Addendum #02 for RFB #947300-01

Project Name: DAS CC Hoover Print Shop Expansion

Date: May 15, 2026

Addendum #02:

1 FIRST FLOOR PLAN - POWER
1/8" = 1'-0"

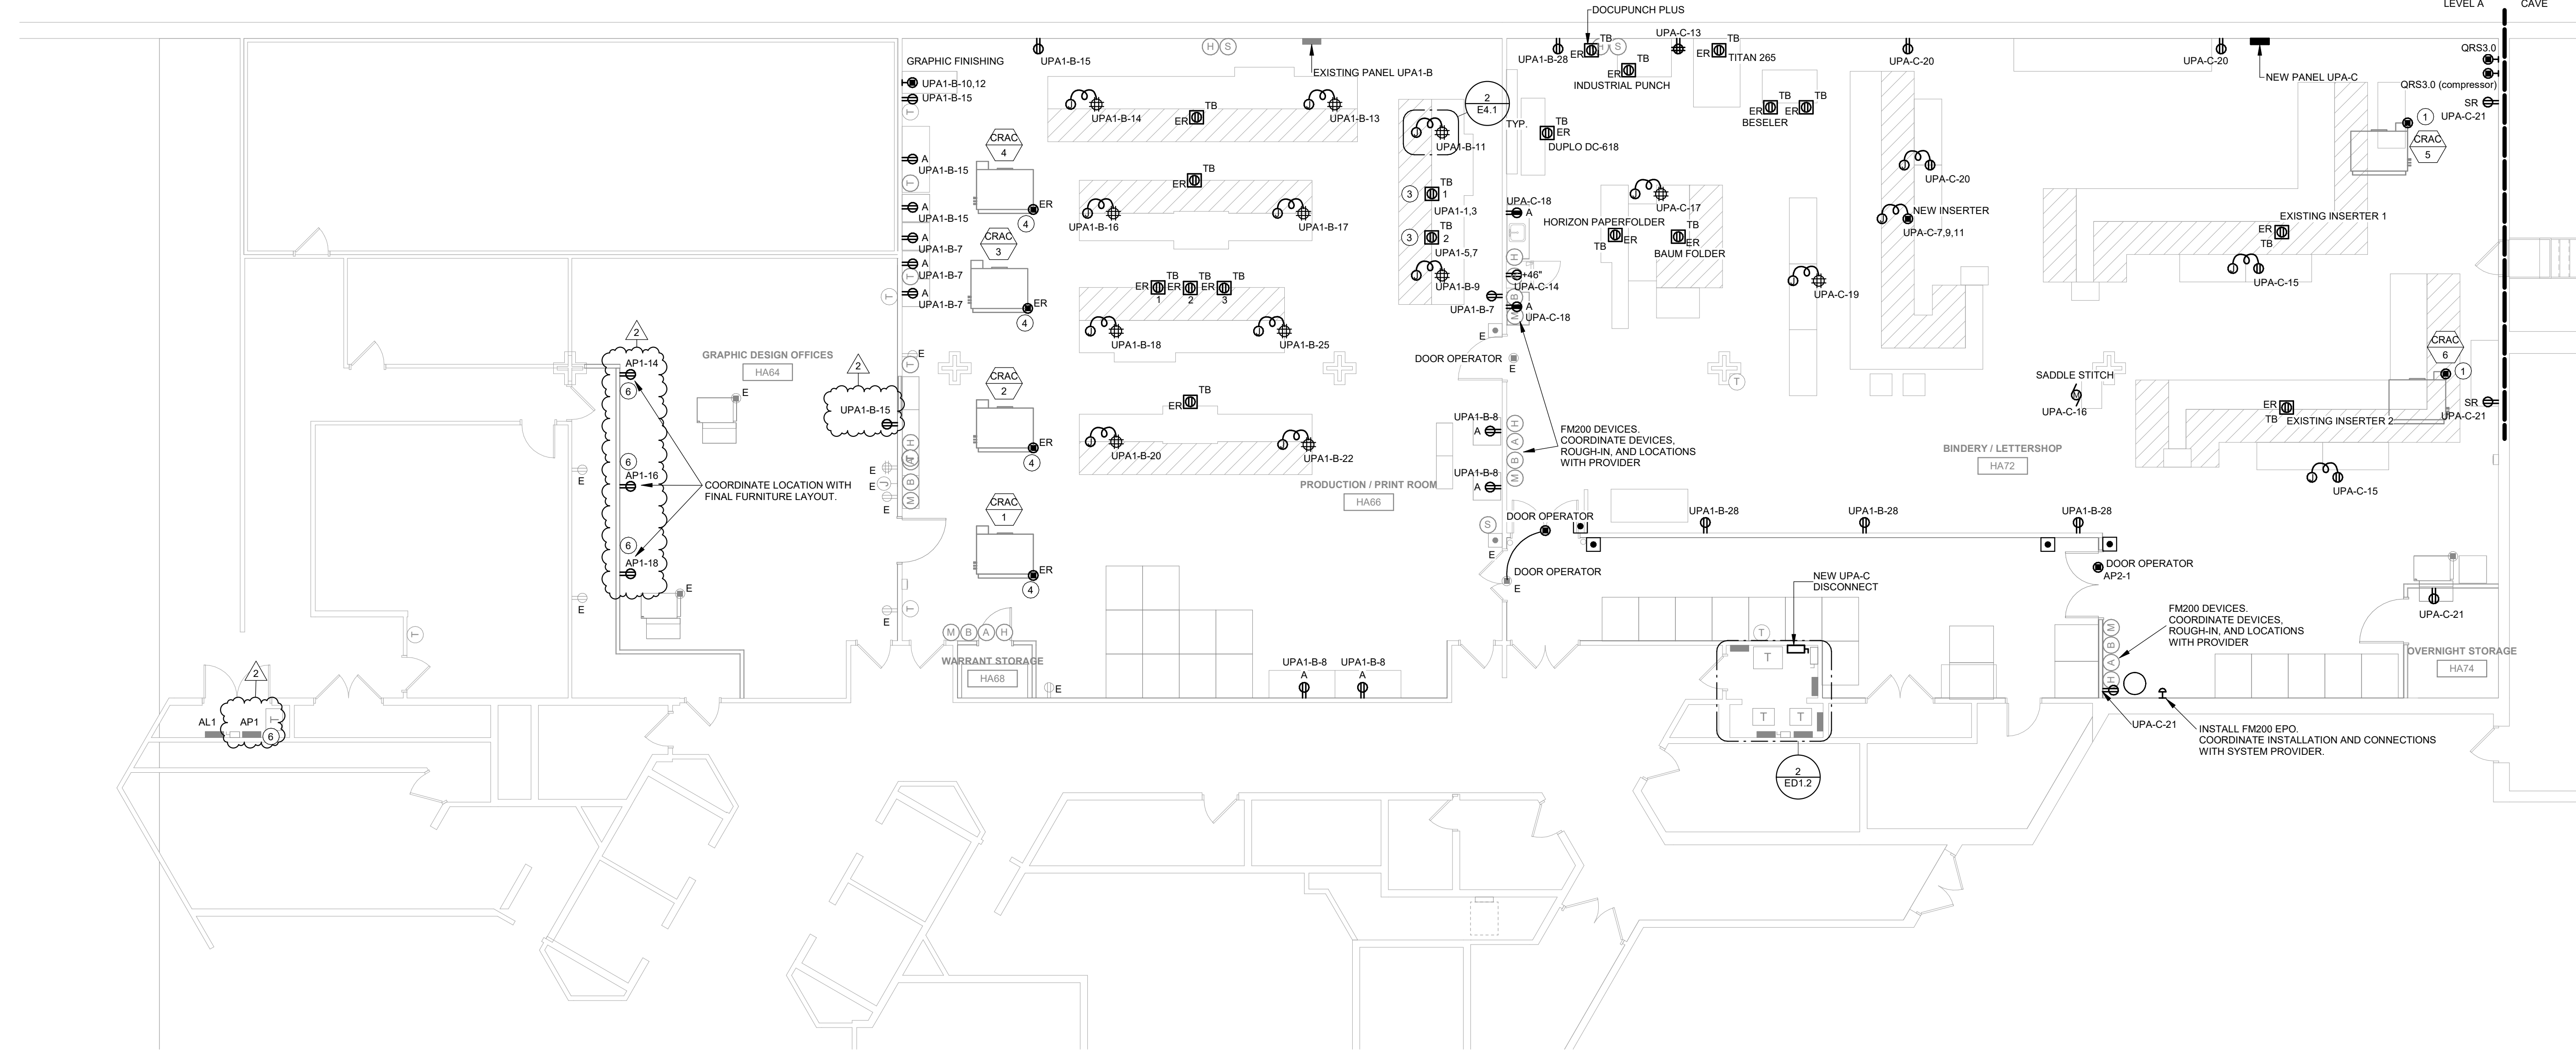
7. Drawing E1.1 – ELECTRICAL POWER:
 - a. Receptacles in print office recircuited to panel AP1.
 - b. Refer to attached full size sheet E1.1.
